REVIEW OF CA-N DATA

802.3by ad-hoc

24/02/2016

3 METRE 26 AWG LANE 1

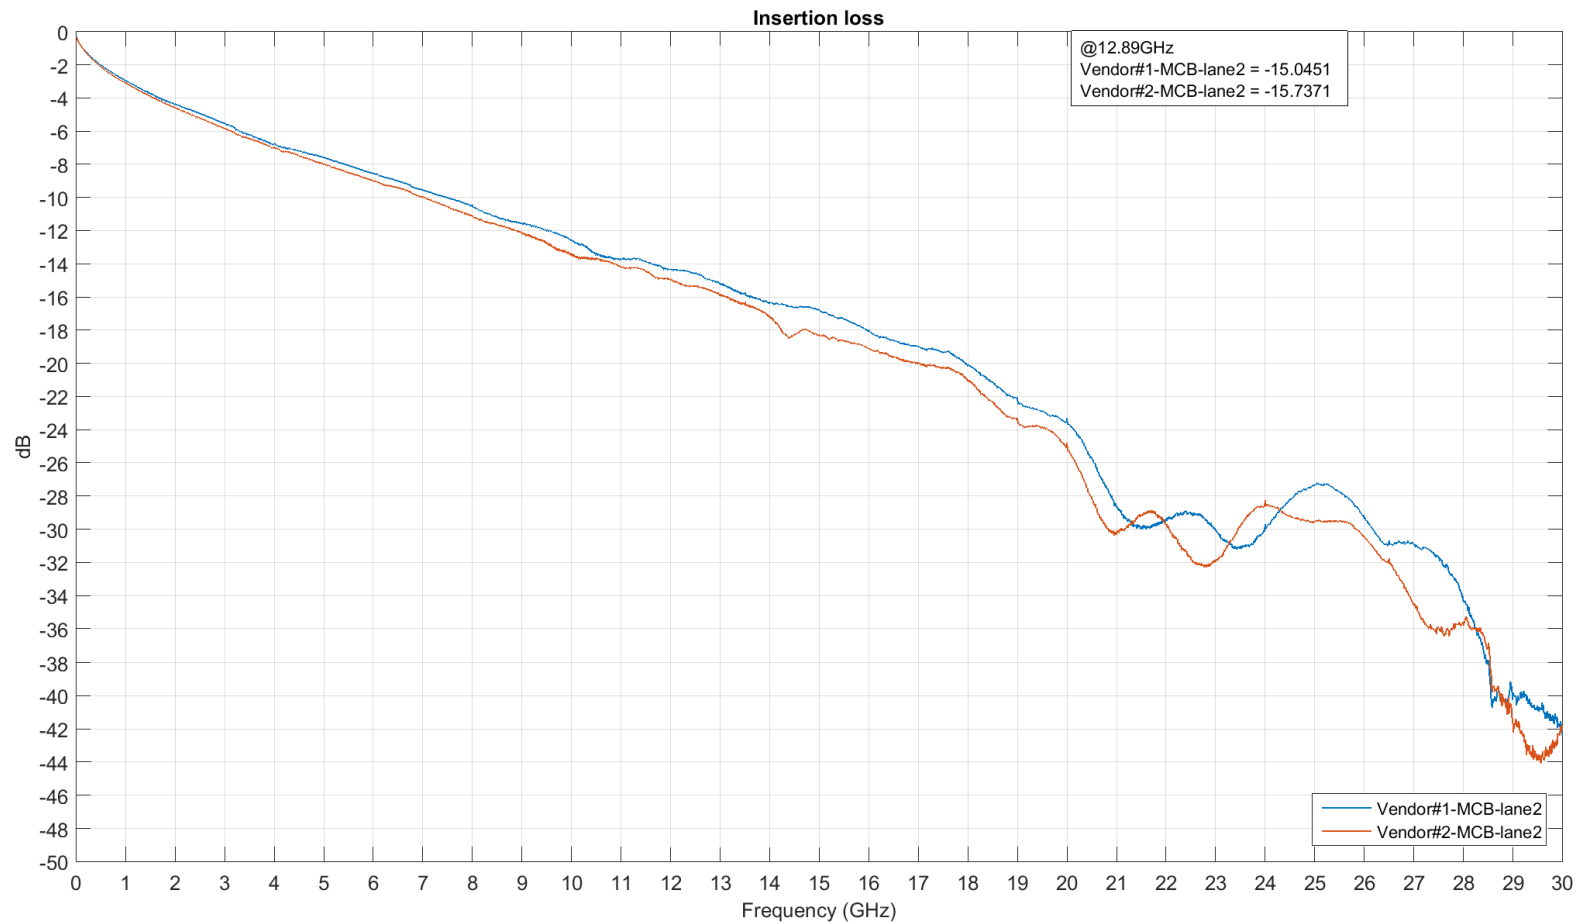
- SFP28-SFP28
- Both MCBs pass the mated test.
- Measurements at 12.89GHz are more than **0.7** dB apart.

3 METRE 26 AWG LANE 2

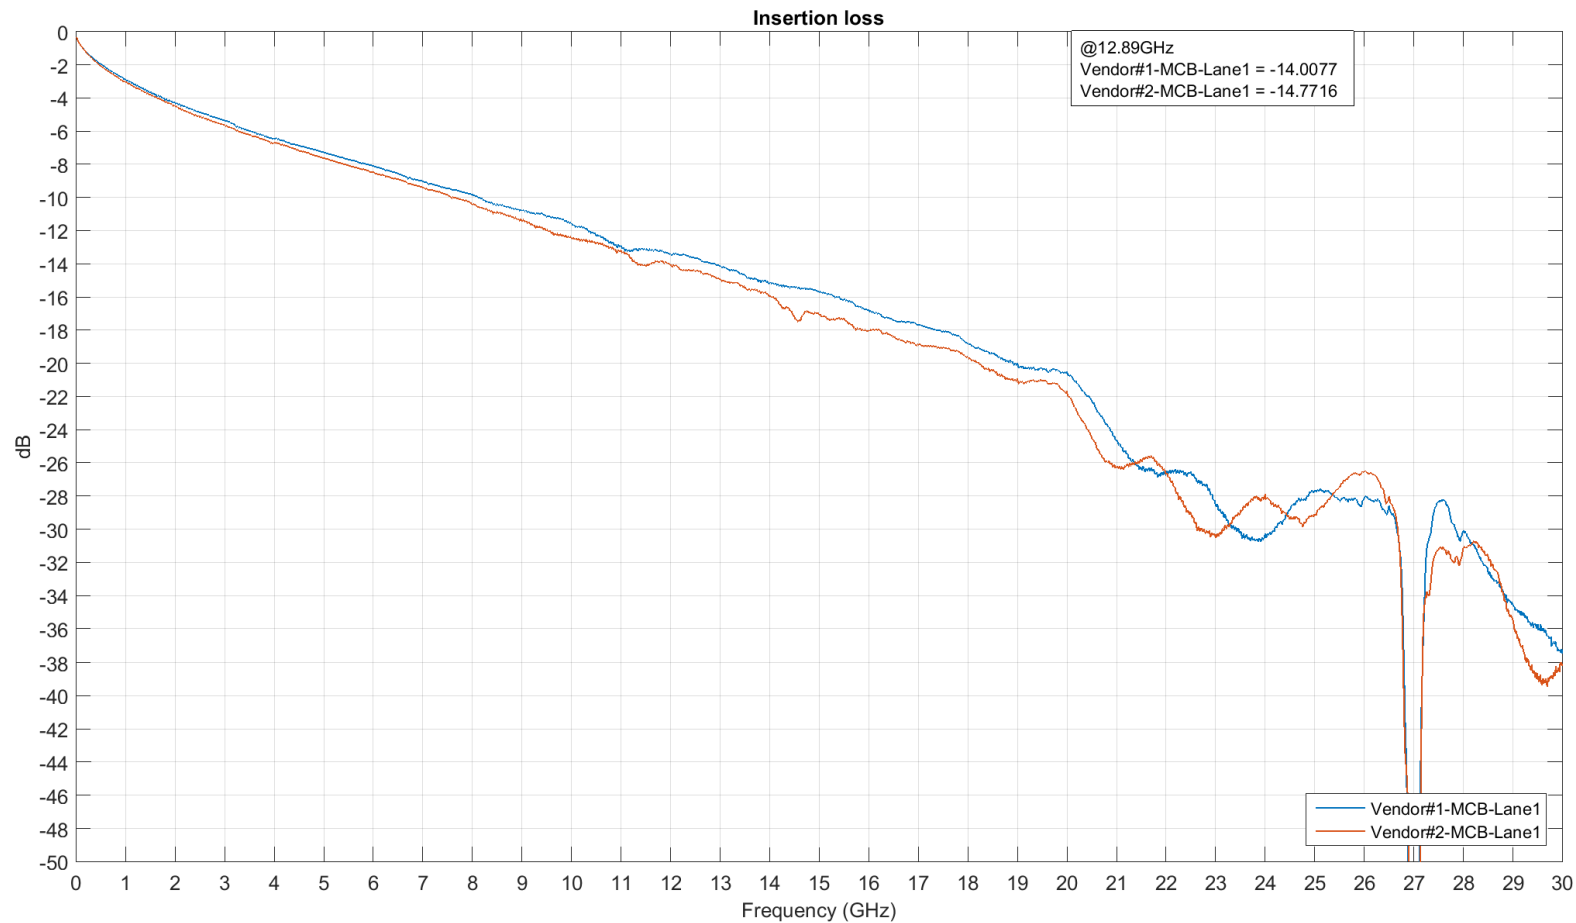
- Both MCBs pass the mated test.
- Measurements at 12.89GHz are more than **0.6 dB** apart.
- SFP-SFP

2 METRE 30 AWG LANE 1

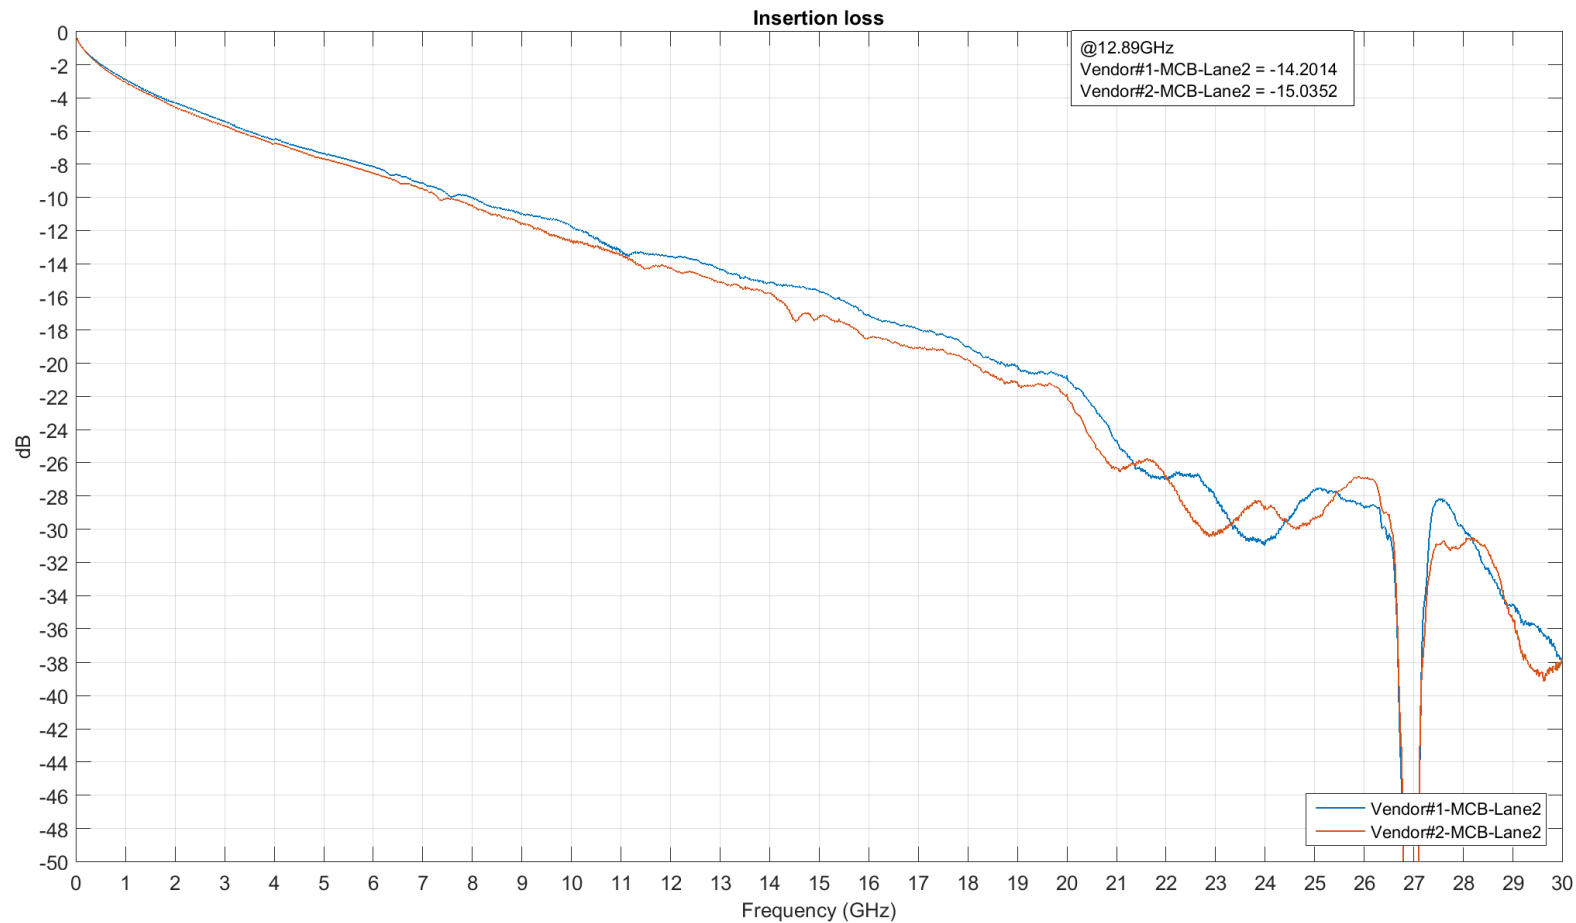
- Both MCBs pass the mated test.
- Measurements at 12.89GHz are more than **0.7** dB apart.
- SFP-SFP
